Planning Commission Study Session

SUBJECT: A. GP14-04, LYON'S GATE PHASE 11: REQUEST FOR MINOR

B. Z14-06, LYON'S GATE PHASE 11: REQUEST TO AMEND ORDINANCE NOS. 1501, 1829, 2010, AND 2191 AND REZONE

Z14-06

Attachment 2 General Plan Exhibit

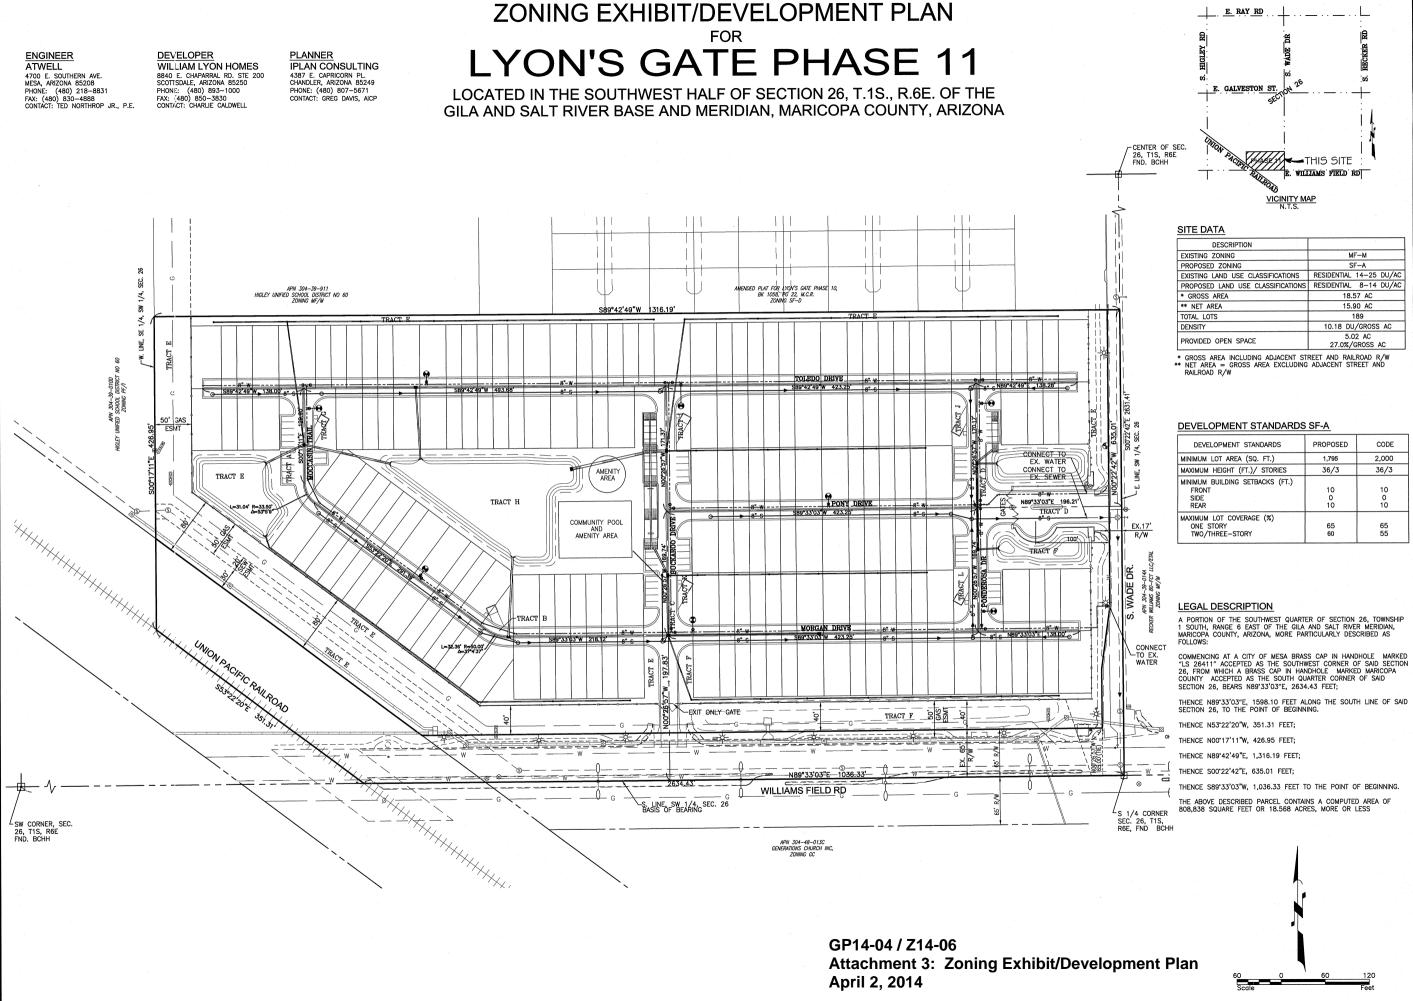
This is a minor amendment of approximately 19 acres known as Parcel 11 of the Lyon's Gate Master Plan within the Gateway Character Area. The General Plan Land Use Map currently classifies the property as Residential 14-25 DU/Acre and the applicant is requesting a lower density classification of Residential 8-14 DU/Acre. The applicant's narrative expresses that in the Gateway Area, there are other sites more suitable for multi-family due to better visibility and proximity to the core of the Gateway Area and the Village Center. He also indicates that the proposal fosters the overall vision, goals and policies of the General Plan by providing diverse housing opportunities.
